SERVICE BULLETIN M20-285

Date: January 19, 2005

- SUBJECT:** STABILIZER TRIM TORQUE TUBE SCORING
- MODELS/ S/N** MOONEY M20K, S/N 25-0002 thru 25-2032
- AFFECTED:** MOONEY M20L, S/N 26-0001 thru 26-0041
MOONEY M20M, S/N 27-0002 thru 27-0328
MOONEY M20R, S/N 29-0001 thru 29-0332, 29-0334 and 29-0338
MOONEY M20S, S/N 30-0001 30-0065

Figure SB M20-285-1

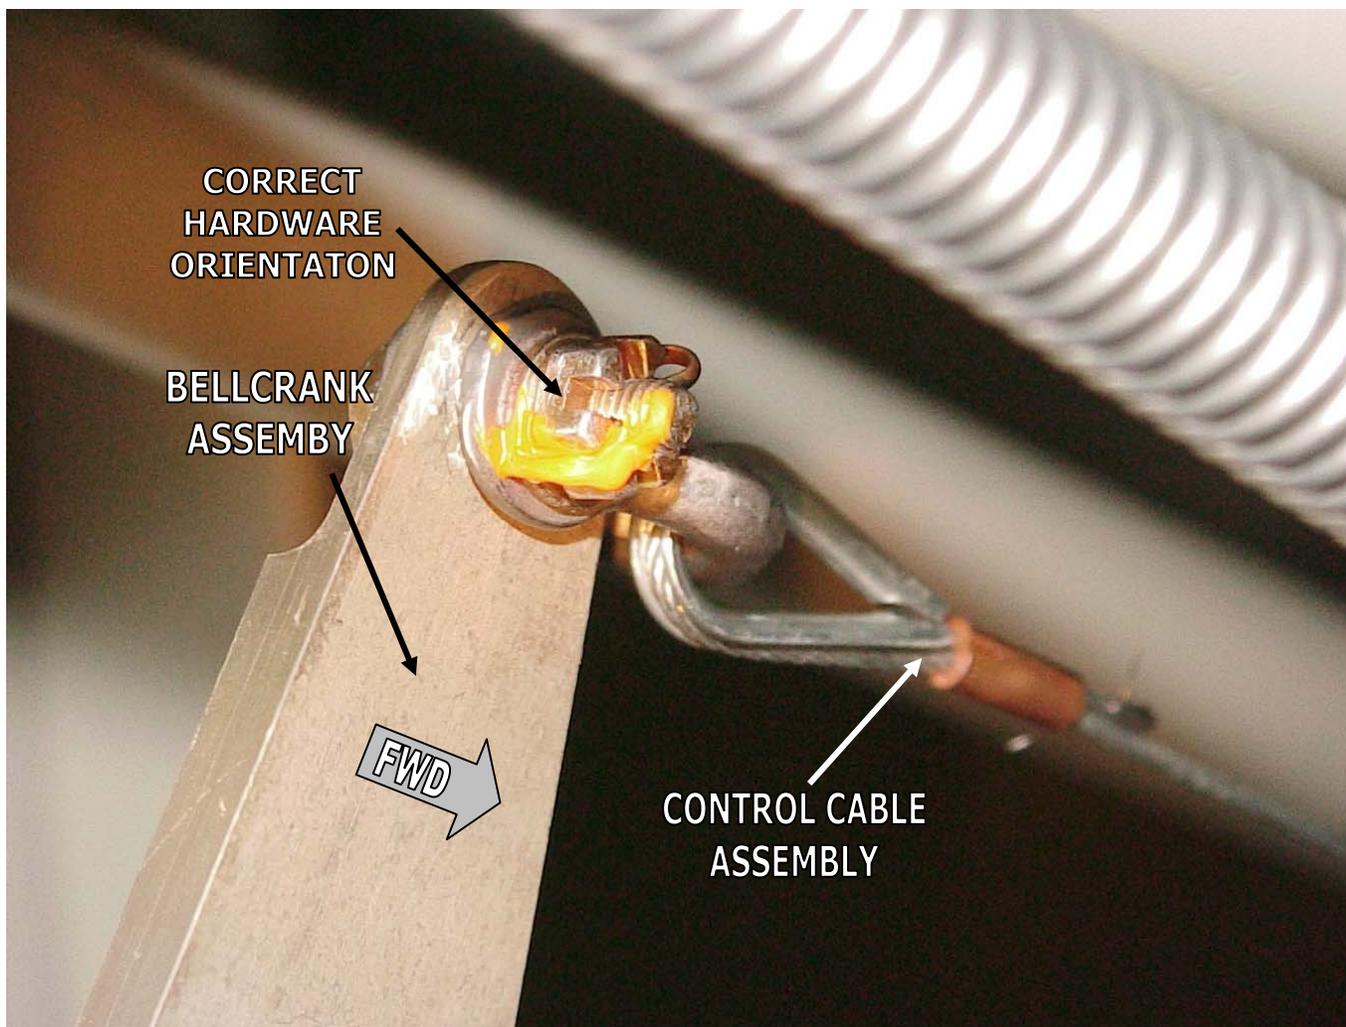
- INTRODUCTION:** There has been a report that the attaching hardware (bolt, washers (4), nut and cotter pin), attaching the Down Spring Control Cable Assembly (710081-501) to the Bellcrank Assembly (710076-501) in the aft tailcone, may have been installed in reverse direction of engineering design.
The threaded end of the bolt should be inserted from aircraft left side to aircraft right side; threaded end pointing in the outboard direction away from the Stabilizer Trim Torque Tube (aircraft centerline).
An incorrect hardware installation orientation may cause scoring of the Stabilizer Trim Torque Tube as a result of the bolt thread contacting the Stabilizer Trim Torque Tube surface during Horizontal Stabilizer trimming movement. Scoring of the Stabilizer Trim Torque Tube could result if attaching hardware is installed incorrectly by maintenance personnel.

2. Locate Bellcrank and verify orientation of mounting hardware at Down Spring Control Cable Assembly attaching point (ref. Figure SB M20-285-1).
 3. If hardware is installed in the proper orientation, reinstall removed Inspection Cover.

6. Temporarily secure Control Cable Assembly to prevent it from falling into Tailcone cavity. Remove existing cotter pin, nut, washers and bolt and discard. Reattach Control Cable Assembly with new hardware (Kit M20-285-1) in correct orientation. Insert bolt with washer from inboard to outboard side of the aircraft. Install washer, castellated nut and cotter. Remove temporary material used to secure Control Cable during procedure. Apply Torque Seal to attaching hardware.

Figure SB M20-285-2

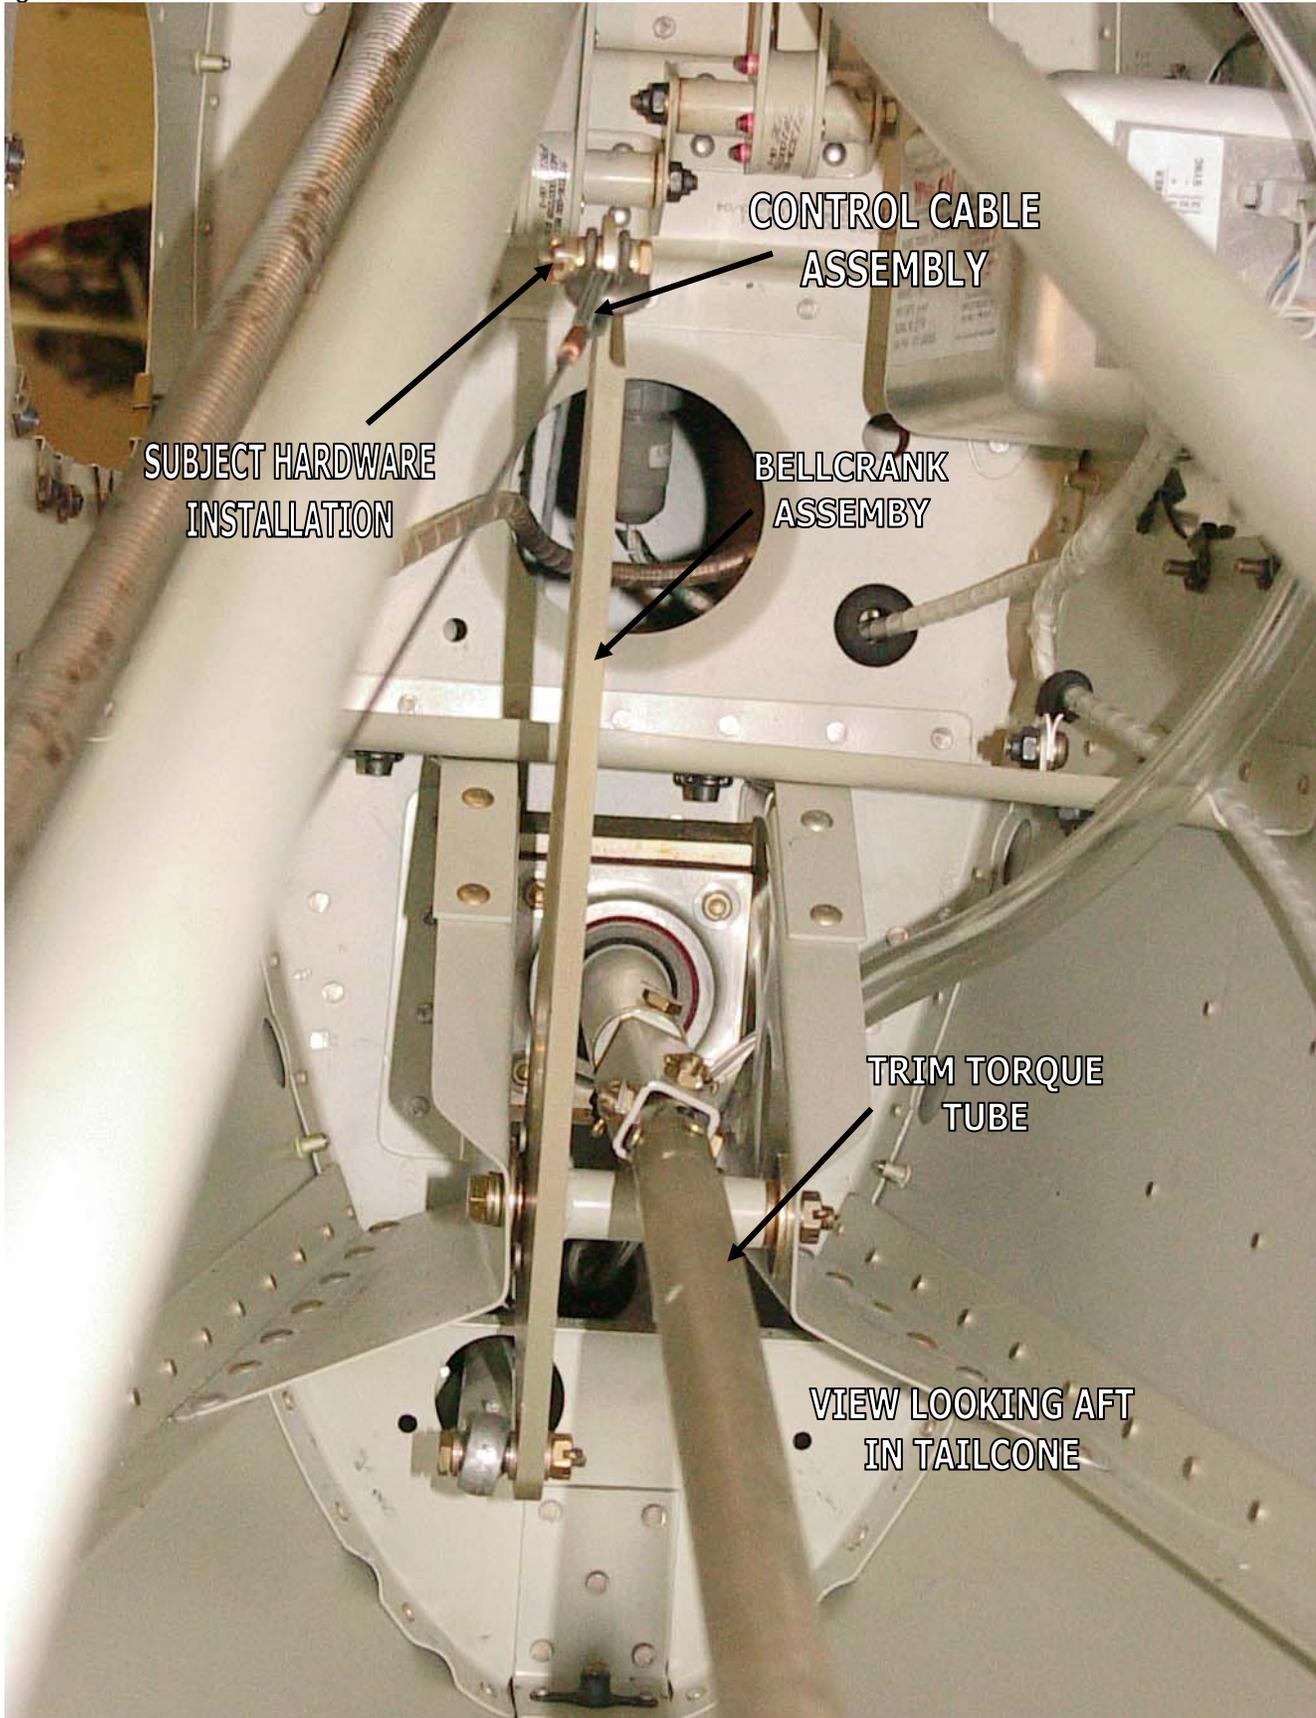
8. Locate and inspect existing Stabilizer Trim Torque Tube for scoring damage created by interference with the Down Spring Bellcrank/Cable attach bolt's threaded end. If scoring has occurred, the Stabilizer Trim Torque Tube (ref. Figure SB M20-285-2) will require replacement.

Figure SB M20-285-3

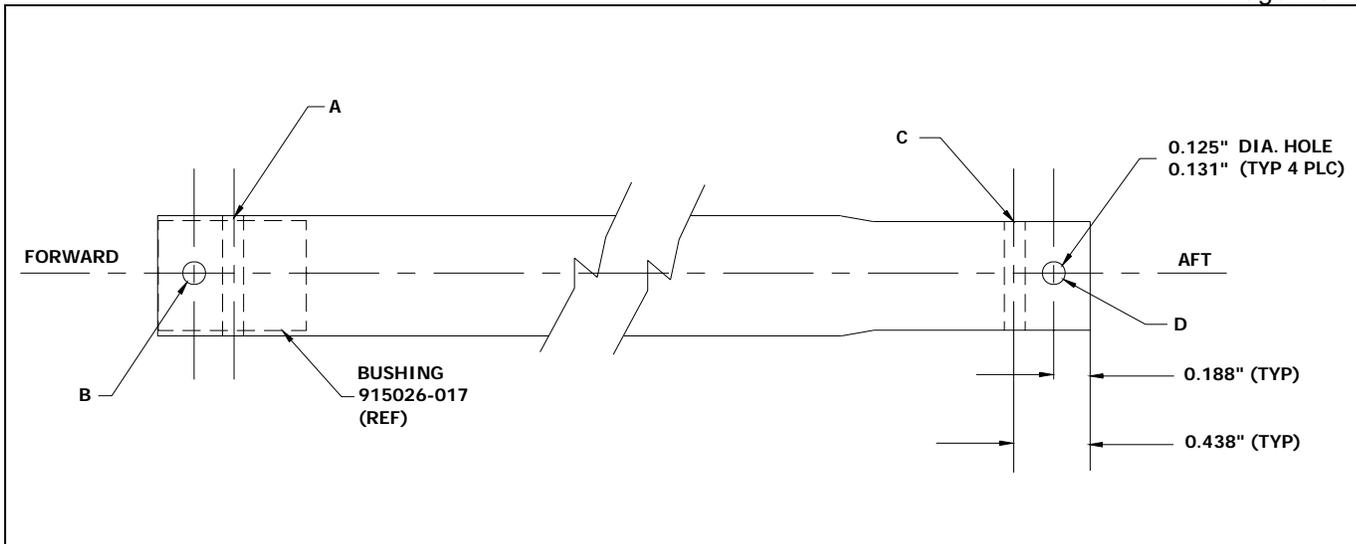
13. Use appropriate method(s) to locate the lateral, center line of the new tube, so both ends will be oriented the same as build up is accomplished.
14. Insert Bushing, 915026-017, into non-swaged end of new Tube, 740192-007. Locate and drill a 0.125 - 0.131 inch diameter hole, 0.438 inches back from the end of the non-swaged end of new tube, 740192-007 and on the center line mark located in Step 13 above. Drill through only one wall of tube and bushing (Refer to Hole "A" Figure SB M20-285-3).

- 16A. On the tube assembly forward end **without an Auto Pilot/Electric Trim system** the 2nd hole 90 degrees from the 1st hole (Refer to Hole "B" Figure SB M20-285-3) will be more difficult to locate so the holes already drilled in the Universal Joint will match with the new hole to be drilled in the tube and bushing. The 2nd hole (B) will be a 0.125 – 0.131 inch diameter hole, 0.188 inches back from the end of the non-swaged end of new tube, 740192-007, and 90 degrees from 1st hole (A).

17. This end of tube, 740192-007, is swaged and the aft Universal Joint, 740009-000, is to be inserted into this swaged end of the tube. Locate and drill a 0.125 – 0.131 inch hole, 0.438 inches back from end of swaged end of tube on the lateral center line of tube as marked in Step 13 above (Refer to Hole "C" Figure SB M20-285-3).
18. Insert the correct end (see NOTE: in Step 11) of aft Universal Joint, 740009-000, into the swaged end and line the drilled hole nearest the end of the Universal Joint with the newly drilled hole in the swaged end of the tube. Verify alignment. Use Universal Joint as drill guide and carefully drill (0.125 – 0.131 inch hole) through the other side of swaged tube wall.
19. Insert existing Clevis Pin, AN392-25, through tube and Universal Joint to secure tube and aft Universal Joint.

Figure SB M20-285-4

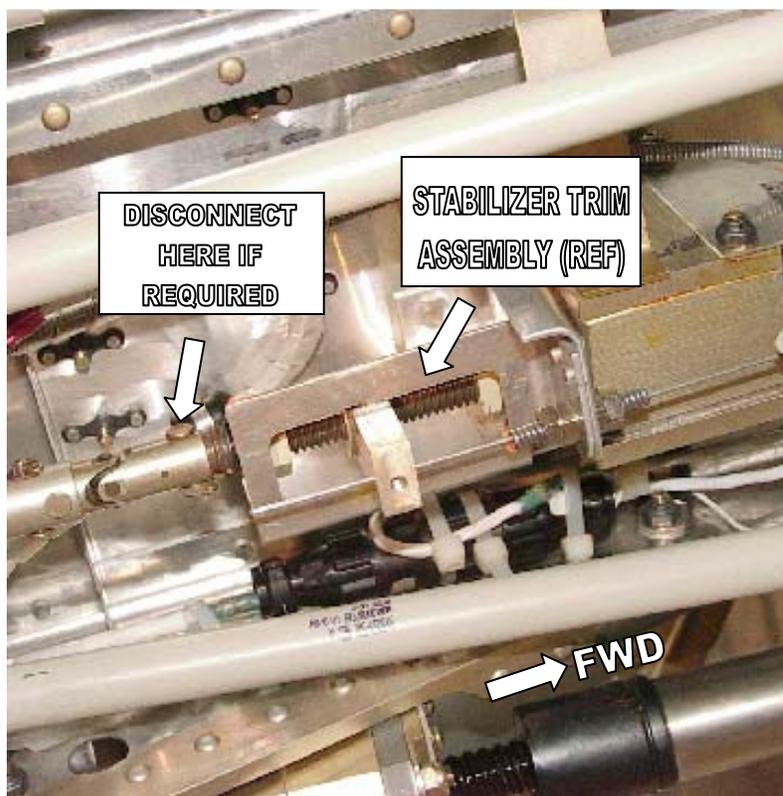
25. To obtain sufficient clearance to slide the forward Universal Joint of the new tube assembly back into its mating tube just forward of Fuse. Sta. 142 bulkhead, the Universal Joint, connected to the Stabilizer Trim Control Wheel Assembly between the Pilot & Co-Pilot seats may have to be disconnected to provide sufficient sliding movement to insert and attach this connection (Refer to Figure SB M20-285-4).
